## FOREST GLEN ROAD SIDEWALK FACILITY PLANNING STUDY BRIEFING

MCPB  
Item No. 5  
10-06-2022

**SUBJECT: Project Briefing: Forest Glen Road Sidewalk Project**  
Proposed sidewalk improvements

*Figure 3 – MCDOT Option 1 Cross Section*

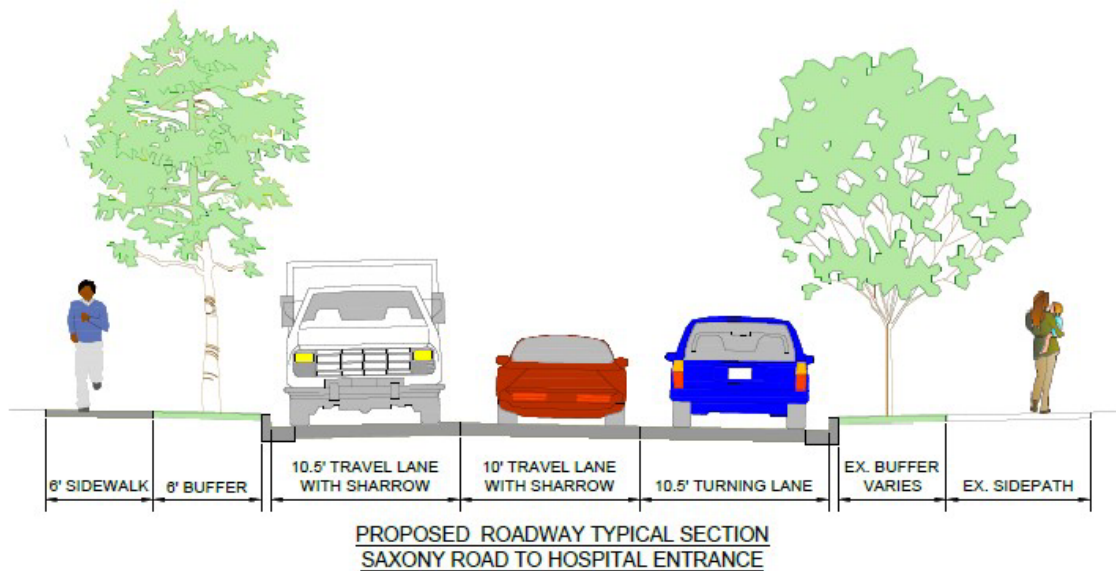
- The six-foot-wide sidewalk on the north side of Forest Glen Road is consistent with the CSDG.
- Despite what is shown in the cross section in Figure 3, the proposed buffer on the north side of Forest Glen Road for most of the corridor is less than the CSDG minimum buffer width of six feet.

- The proposed through travel lane widths on Forest Glen Road are consistent with the CSDG.
- The existing buffer on the south side of Forest Glen Road varies considerably (0 to 22 feet). There are some segments where the buffer is less than six feet.

- The existing sidepath on the south side of Forest Glen Road is only eight-feet wide, which meets minimum CSDG standards; however, this minimum is typically used only in environmentally constrained areas.

- The existing sidepath on the south side of Forest Glen Road does not extend to the project limits (Sligo Creek Parkway). This is inconsistent with the Bicycle Master Plan and the Forest Glen/Montgomery Hills Sector Plan.

*Figure 4 – MCDOT Option 2 Cross Section*

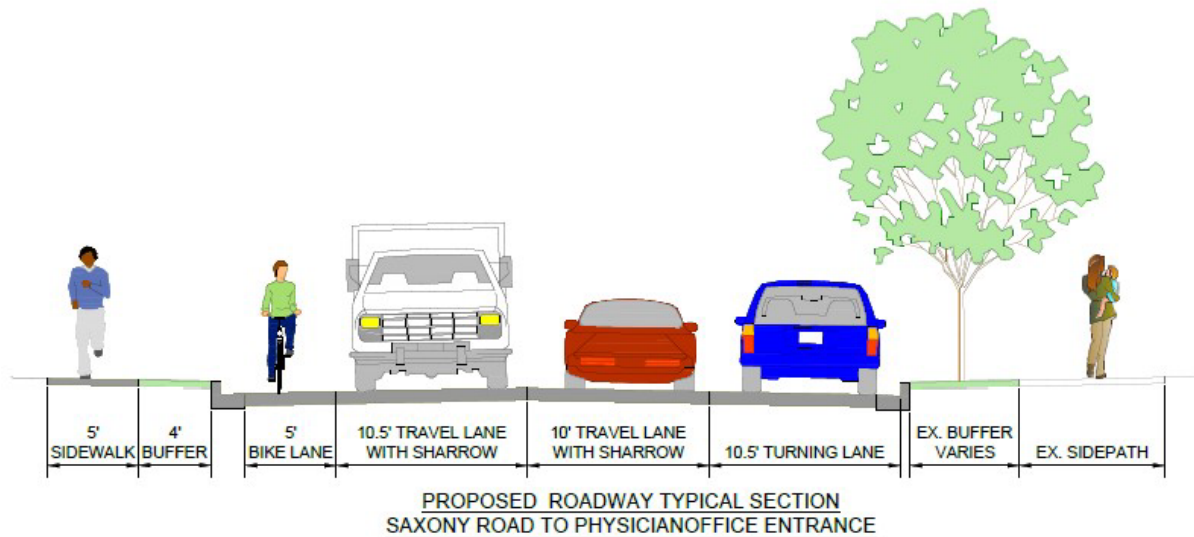
- The five-foot-wide sidewalk on the north side of Forest Glen Road is not consistent with the CSDG which specifies a six-foot minimum width.
- The proposed westbound bike lane is not included in either the Bicycle Master Plan or the Forest Glen/Montgomery Hills Sector Plan, but can be added per the Bicycle Master Plan if it does not detract from the provision of a sidepath.

- The proposed buffer on the north side of Forest Glen Road ranges from no buffer to a maximum of four feet, and therefore is less than the CSDG minimum buffer width of six feet.

- The proposed through travel lanes on Forest Glen Road are consistent with the CSDG.
- The existing buffer on the south side of Forest Glen Road varies considerably (0 to 22 feet). There are some segments where the buffer is less than six feet.

- The existing sidepath on the south side of Forest Glen Road is only eight-feet wide, which meets minimum CSDG standards; however, this minimum is typically used only in environmentally constrained areas.

- The existing sidepath on the south side of Forest Glen Road does not extend to the project limits (Sligo Creek Parkway). This is inconsistent with the Bicycle Master Plan and the Forest Glen/Montgomery Hills Sector Plan.

*Figure 6 – Option 3 - Master Plan Vision Cross Section*

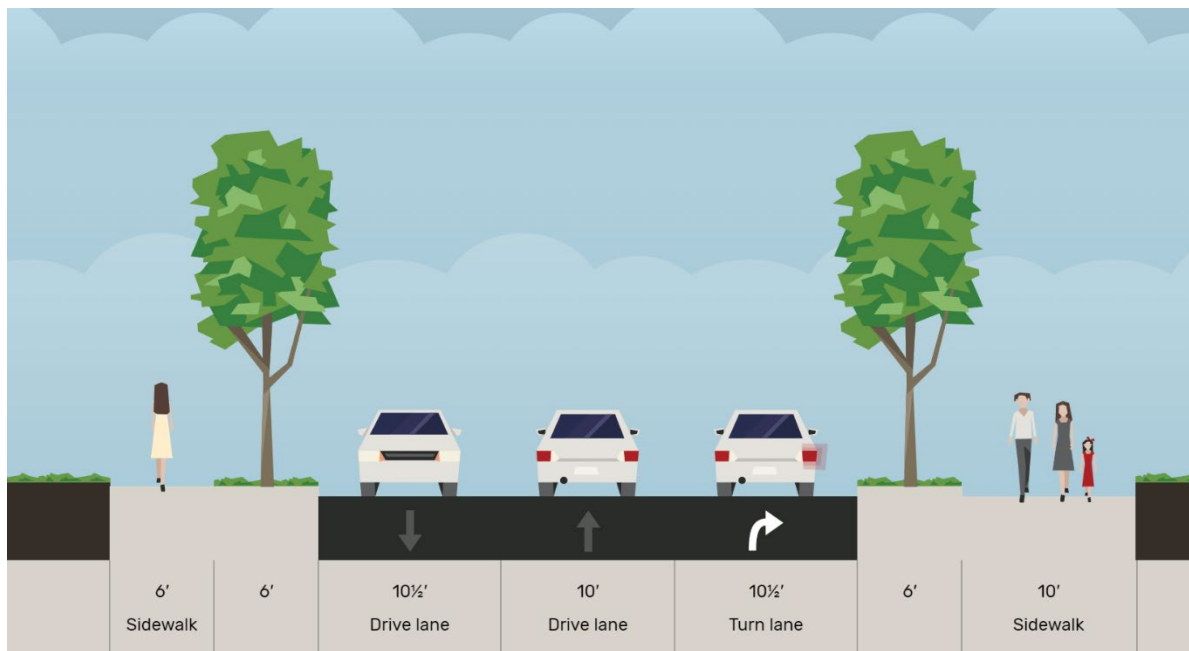
Planning Staff first developed an option to address the long-term master plan vision. Option 3 provides all facilities identified in the Master Plan of Highways and Transitways and with dimensions and priorities from the CSDG. Option 3 is displayed in Figure 6.

Option 3 provides a six-foot-wide sidewalk, six-foot-wide minimum buffers on both sides of the street, two 10.5-foot-wide travel lanes, an exclusive eastbound right-turn lane where it currently exists, and a 10-foot-wide sidepath along the corridor extents (Woodland Drive to Sligo Creek Parkway). This is a generalized cross section (59.5 feet wide) and does not apply uniformly across the study area. The exclusive right-turn lane depicted only exists between Saxony Drive and the hospital driveways.

3. If the spatial requirements of an uphill bicycle lane create excessive property impacts or costs, the Planning Board recommends Option 3. If this option entails prohibitive costs, the Planning Board recommends pursuing Option 1. The Board understands the importance of advancing a sidewalk along the north side of Forest Glen Road, to ensure that this sidewalk is present when the Forest Glen Passageway project is completed.

Figure 7 – Option 4 - Master Plan Vision Cross Section with Climbing Lane

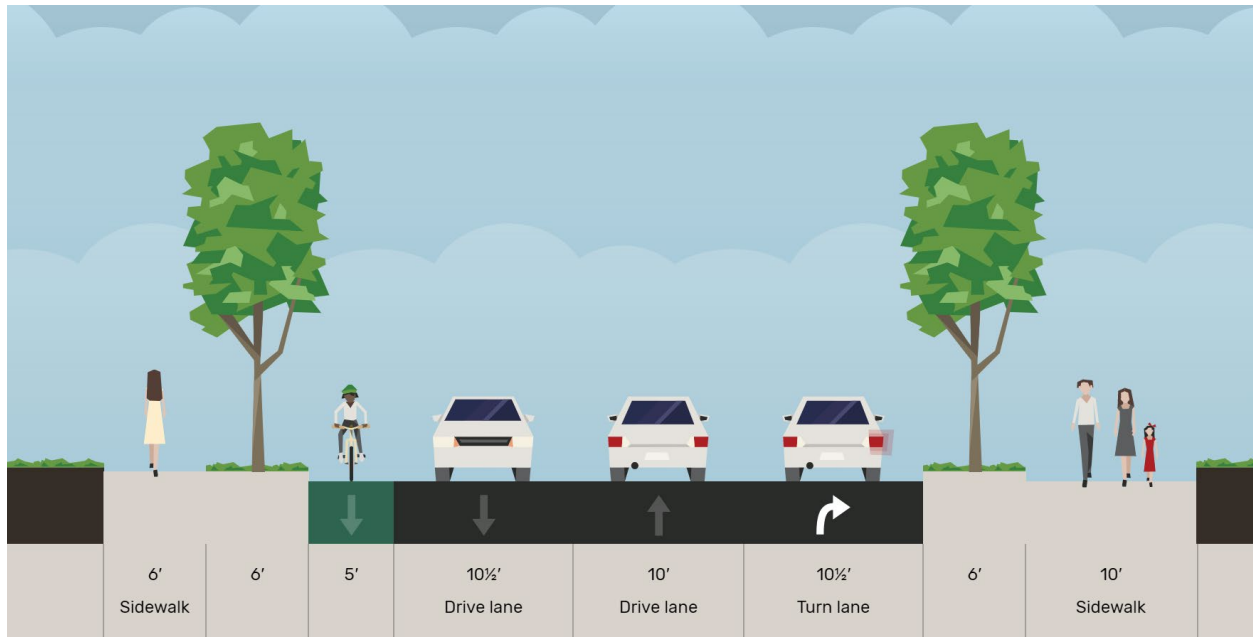
In addition, Planning Staff agrees with some of the concerns raised by WABA. The addition of a westbound bike lane (in the uphill direction) is a great suggestion, despite not being a current master plan recommendation. Planning Staff therefore identified Option 4, which would build on Option 3 with the addition of a westbound five-foot-wide bike lane. This cross section would be 65 feet wide. Option 4 is shown below in Figure 7. Note that the westbound through travel lane shown in Option 4 is 11-feet-wide compared to the 10.5-feet used for Option 3. This additional ½ foot is needed when adjacent to a bike lane to provide a total distance of 16 feet (travel lane plus bike lane).

2. The Planning Board endorses Option 4 as the design concept that best matches the Master Plan requirements and the standards in the Complete Streets Design Guide (CSDG) and addresses valid concerns from the bicycling community.
